PCN/22/001/C+N-US

Product Range: Han

Title: Change Han TC70, TC100 and Han TC200

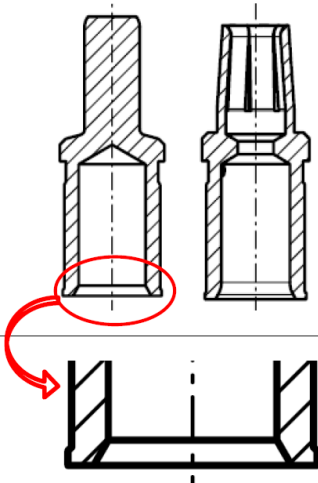
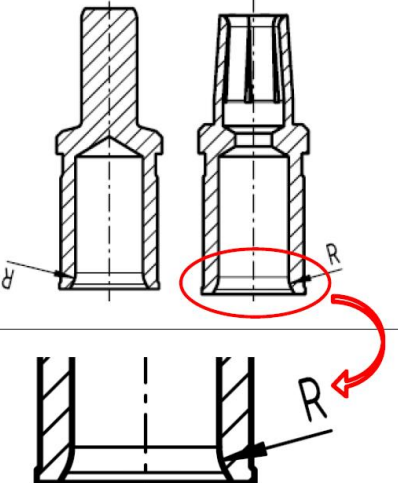
1. Concerned Part Numbers		
See appendix.		
2. Description of Changes/News		
Old Design	New Design	Description
		<p>Implementation of a radius to the end of the inlet funnel of the crimp hole. This change optimizes handling in the crimping process.</p>
3. Impact on Product Specification		
The technical characteristics according to the datasheet and also the quality characteristics are not affected.		
4. Scheduled Date of Implementation		
This change will take place as of September 2 nd , 2022. Mixed deliveries may be possible.		
5. Identification of Change		
New revision level.
